# UNITED STATES PATENT AND TRADEMARK OFFICE

APPLICATION NO.	FILING DATE	FIRST NAMED INVENTOR	ATTORNEY DOCKET NO.	CONFIRMATION NO.
09/975,163	10/11/2001	Daniel Xu	INTO-0008-US(P12501)	9107
7590	02/12/2004		EXAMINER KEBEDE, BROOK	
Timothy N. Trop TROP, PRUNER, HU, P.C. 8554 KATY FWY, STE 100 HOUSTON, TX 77024-1805			ART UNIT	PAPER NUMBER
			2823

<b>Office Action Summary</b>	<b>Application N .</b>	<b>Applicant(s)</b>	
	09/975,163	XU, DANIEL	
	<b>Examiner</b>	<b>Art Unit</b>	
	Brook Kebede	2823

**FIG. 1**

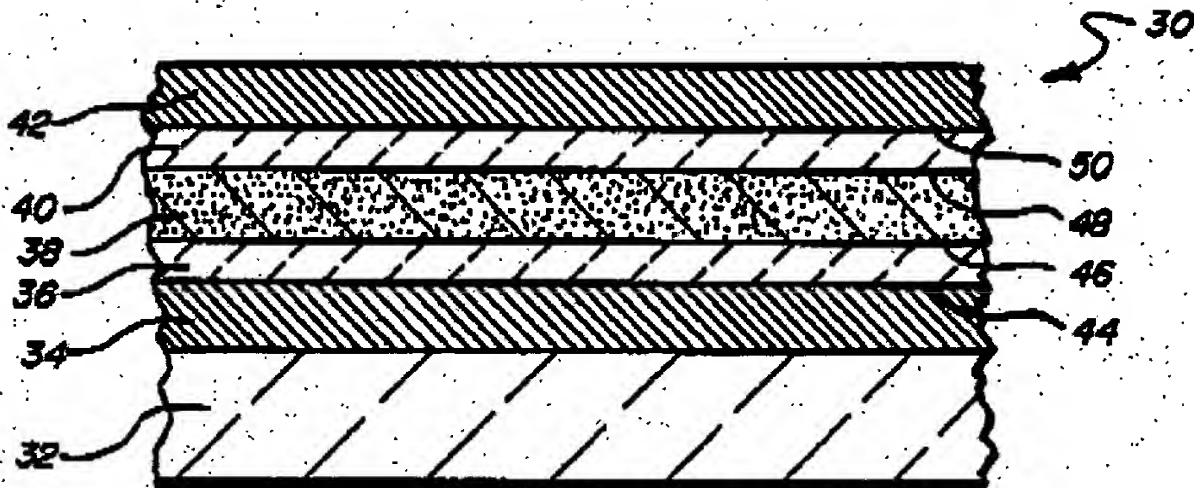
In response to the applicant's argument, the Examiner respectfully submits that such an argument is not commensurate with the scope of the claims, in particularly, as stated above. The Examiner respectfully submits that, in contrary Applicant's argument, Pryor et al. '533 teach forming trench using the tapered electrode as mask. The Examiner respectfully submits Figs. 1-3 of Pryor et al. '533 herein below:

As shown above, layers 38, 40 and 42 are etched to form the tapered electrode as depicted in Fig. 2 as follows:

**FIG. 2**

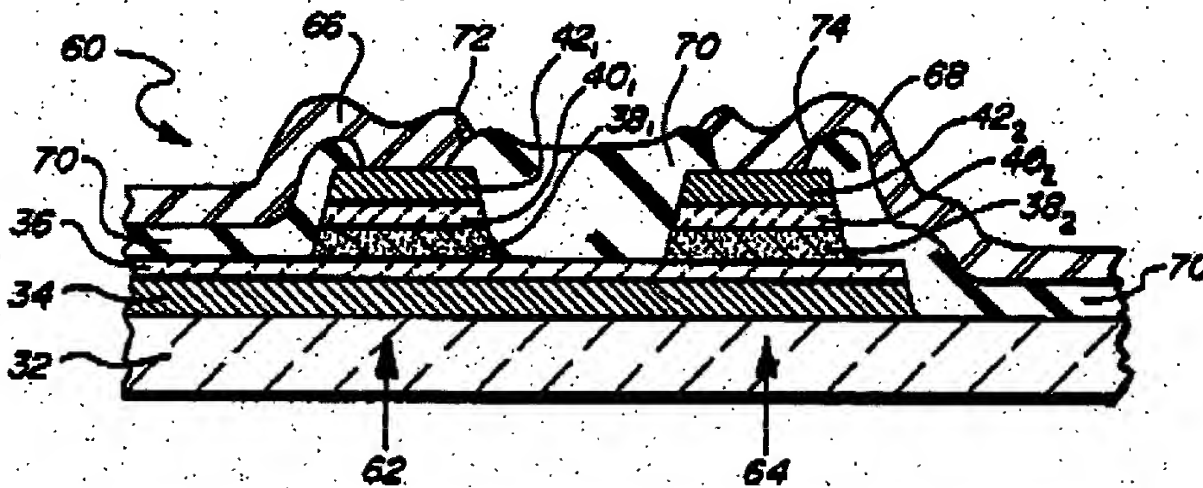
Note that in Fig. 2, layers 34 and 36 are not etched. However, in Fig. 3 layers 34 and 36 are etched using the tapered electrode (38 40 42) as a mask as shown below in Fig. 3 to form a trench (cut in).
